## Assessment Report:

Temporary Emission Licence

Abbot Point Terminal 1

(Abbot Point Bulk Coal Pty Ltd)

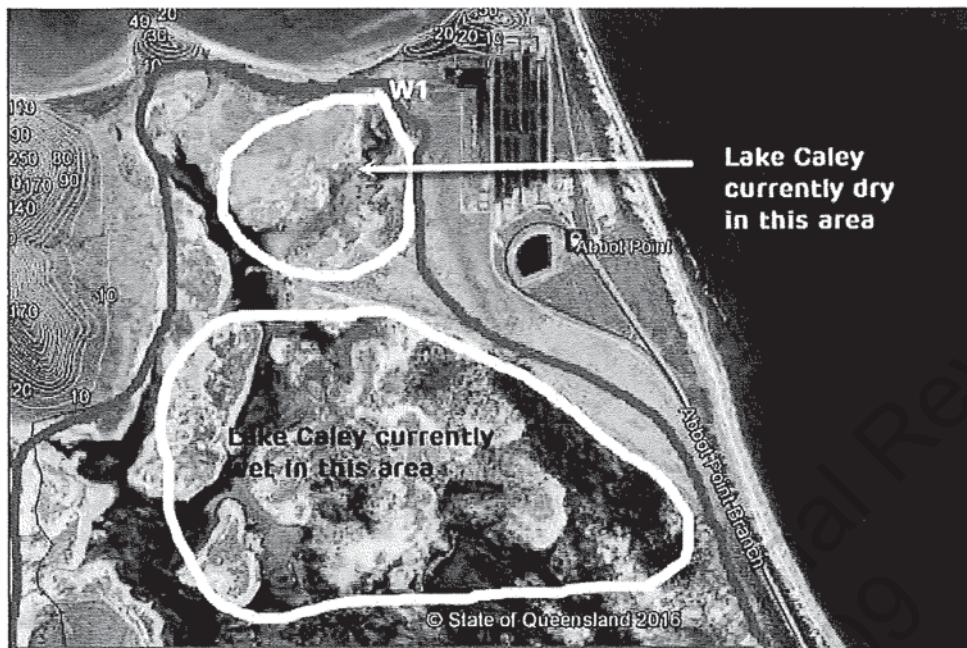
- The receiving environment is currently dry, but there are other locations of the wetland that contains water (south). Refer to the image below.
